Minute No. 617
Report - Standing Policy Committee on Infrastructure Renewal and Public Works - September 11, 2007

Item No. 5 **Private Approach - southwest corner of Broadway and Sherbrook Street**
(Fort Rouge-East Fort Garry Ward)
File SC-1(32)

RE: ACCESS TO A PROPOSED PARKING LOT LOCATED AT THE SOUTHWEST CORNER OF BROADWAY AND SHERBROOK STREET

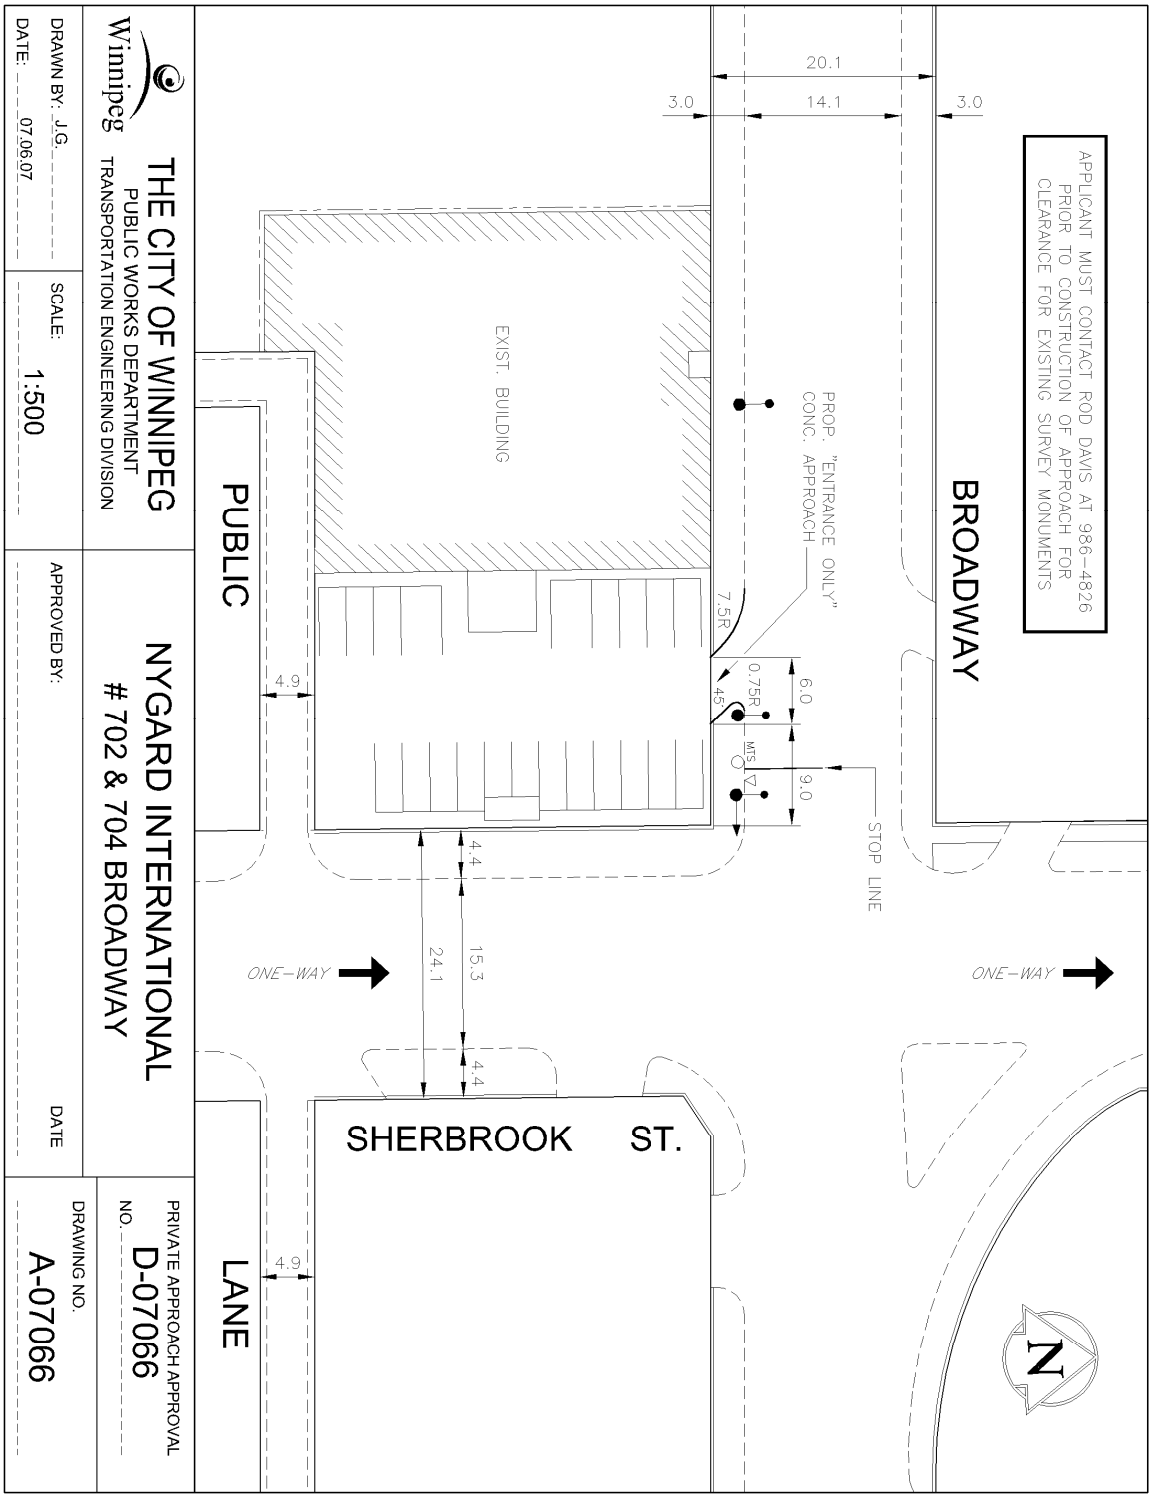
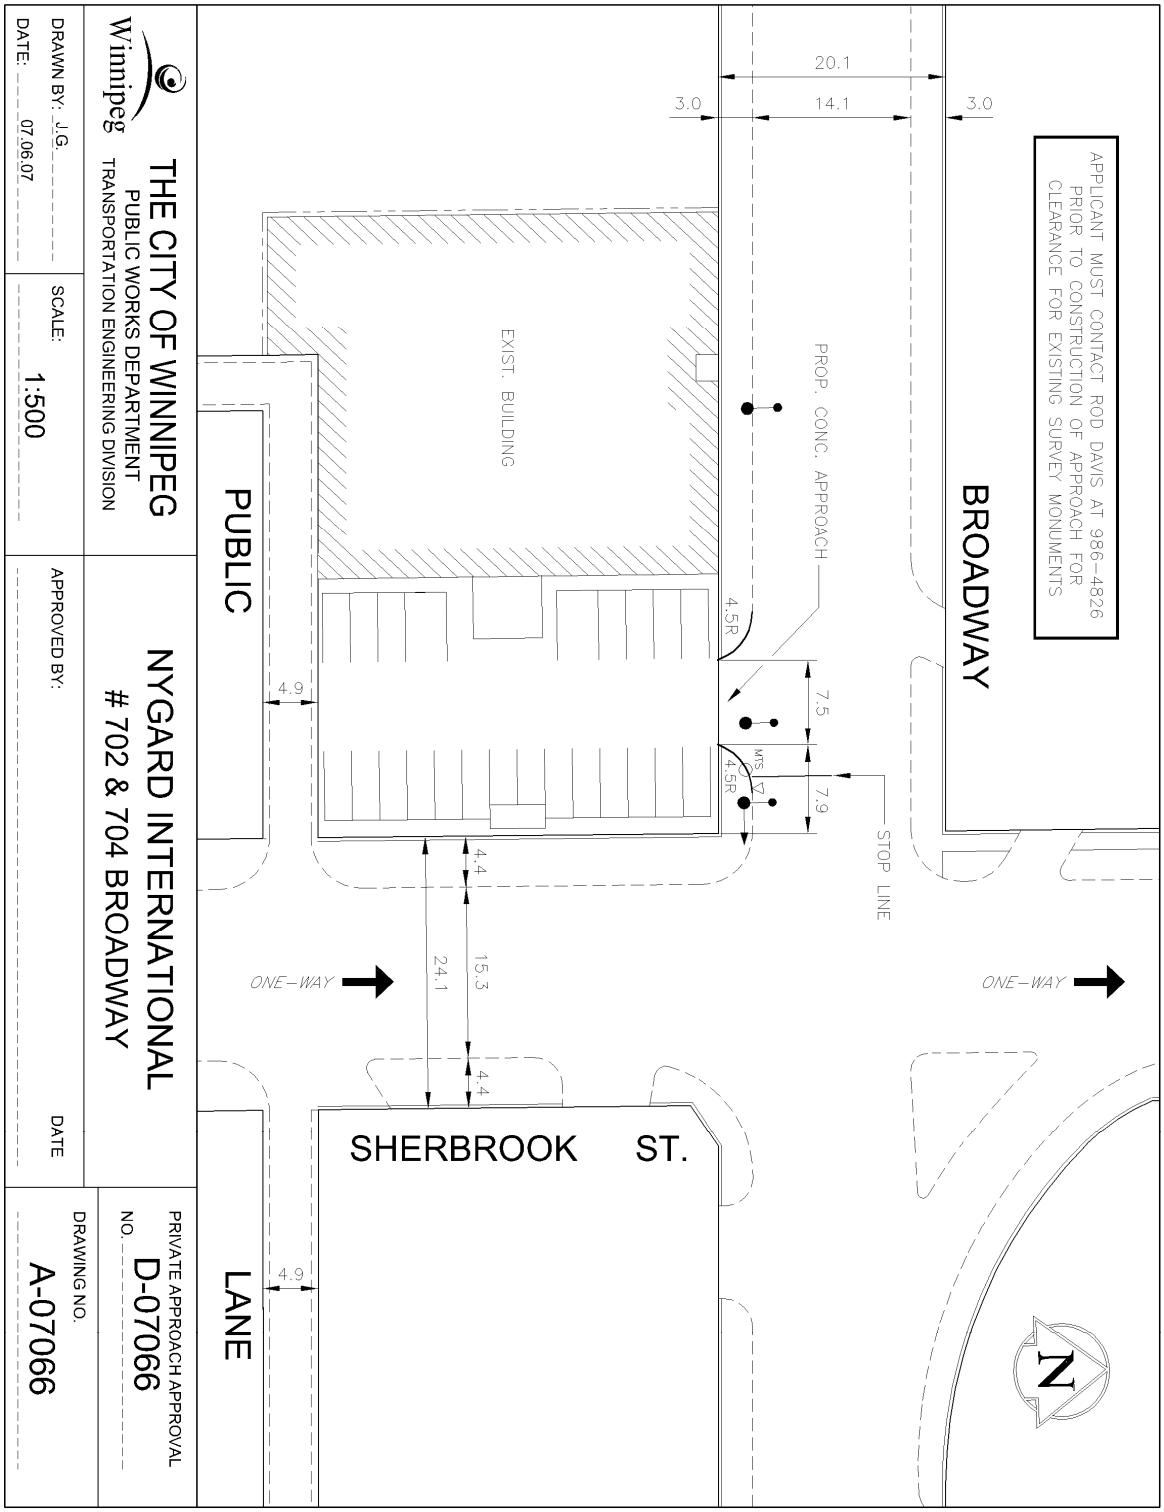
- The proposed private approach (as shown on Drawing No. A-07066) is not permitted by the Private Approaches By-law No. 6546/95.

The proposed private approach on the south side of Broadway is not permitted by subsection 3(2) of the Private Approaches By-law No. 6546/95:

This Department submitted a report for a non-conforming bi-directional private approach on the south side of Broadway to the Standing Policy Committee on Infrastructure Renewal and Public Works for its meeting on July 3, 2007. This Department's report recommended that the Committee *not* approve this non-conforming bi-directional private approach. The Committee laid over this matter at the request of the applicant. A revised plan has been submitted to this Department, which includes an angular "entrance only" private approach on the south side of Broadway, as illustrated on Drawing No. A-07066.

Proposed access to the proposed parking lot will be from a proposed non-conforming angular "entrance only" private approach on the south side of Broadway and the east-west public lane south of Broadway.

The Private Approaches By-law does not permit any private approaches to be constructed on this section of Broadway. However, this Department recommends that the Committee approve this application, as it is not expected that this angular “entrance only” private approach will cause any traffic operating problems on either Broadway or Sherbrook Street.

1. That Schedule 1 of the Private Approaches By-law No. 6546/95 be amended to permit the construction of a 6.0 metre private approach on the south side of Broadway, 9.0 metres west of Sherbrook Street (as shown on Drawing No. A-07066).

That the Standing Policy Committee on Infrastructure Renewal and Public Works order that the Private Approaches By-law No. 6546/95 be varied to authorize the construction of a 6.0 metre private approach on the south side of Broadway, 9.0 metres west of Sherbrook Street (as shown on Drawing No. A-07066).
